Access Compliance Report Public Rights-of-Way (Curb Ramps)

Main Street: NARROW_CANYON_RD **Cross Street:** N/A **Location:** SE

ADA ID: RPRK211028131519 **Ramp Type:** Type 4 - Parallel **Initial Pass/Fail:** Pass **Overall Compliance:** No **Severity Score:** 26

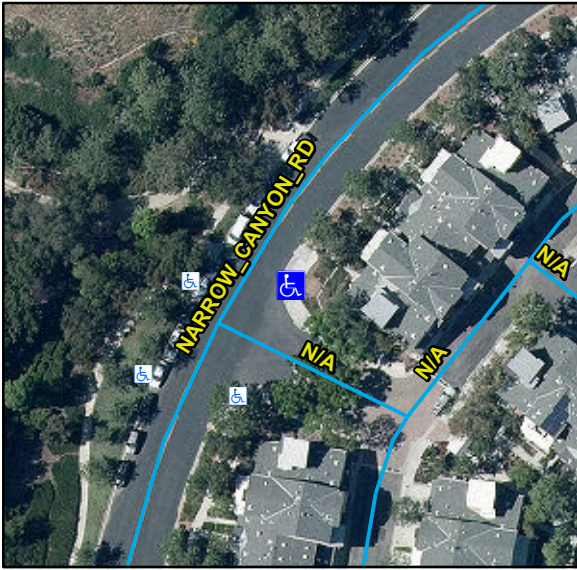
Compliance	Description	Data	Compliance	Description	Data
N/A	Ramp Length LT (in)	139	N/A	Ramp Length RT (in)	146
Yes	Ramp Width LT (in)	90	Yes	Ramp Width RT (in)	90
Yes	Ramp Run Slope LT (%)	7.7	Yes	Ramp Run Slope RT (%)	3.2
Yes	Ramp Cross Slope LT (%)	1	No	Ramp Cross Slope RT (%)	2.5
N/A	Landing Present	No	No	DWS Provided	No
N/A	Landing Length (in)	N/A	N/A	DWS Contrast	N/A
No	Landing Width (in)	N/A	N/A	DWS Length (in)	N/A
No	Landing Run Slope (%)	N/A	N/A	DWS Full Width	N/A
No	Landing Cross Slope (%)	N/A		DWS Offset Type	N/A
N/A	Landing Movement Obstructed?	No	N/A	DWS Offset Left (in)	N/A
	Landing Movement Type	Curb	N/A	DWS Offset Right (in)	N/A
N/A	Landing Shared	N/A			
N/A	Clear Space	Yes			
N/A	Clear Space To Crosswalk (in)	48			
N/A	Marked Crosswalk 1	No	N/A	Marked Crosswalk 2	No
	Crossing 1 Direction	N		Crossing 2 Direction	SW
N/A	Marked Crosswalk 1 Width (in)	N/A	N/A	Marked Crosswalk 2 Width (in)	N/A

N/A	Ramp Inside Crosswalk 1	N/A	N/A	Ramp Inside Crosswalk 2	N/A
	Crossing 1 Slope (%)	3.8		Crossing 2 Slope (%)	2.9
	Crossing 1 Cross Slope (%)	2.6		Crossing 2 Cross Slope (%)	2.5
Yes	Gutter Ponding	No	No	Curb Slope	9.3
Yes	Gutter Lip Height (in)	0		Road Run Slope (%)	3.1
No	Gutter Run Slope (%)	11.2		Road Cross Slope (%)	0.3
Yes	Gutter Cross Slope (%)	2.2	No	Perpendicular Joint Present	No
Yes	Overall Surface Condition	Acceptable			
	Cross Gutter Present?	No		Spandrel Present?	No
	Replace Cross Gutter?	N/A		Replace Spandrel?	N/A

Possible Solutions:
Remove & Replace Curb Ramp With Two New Directional Ramps or Equivalent. Remove & Replace Gutter.
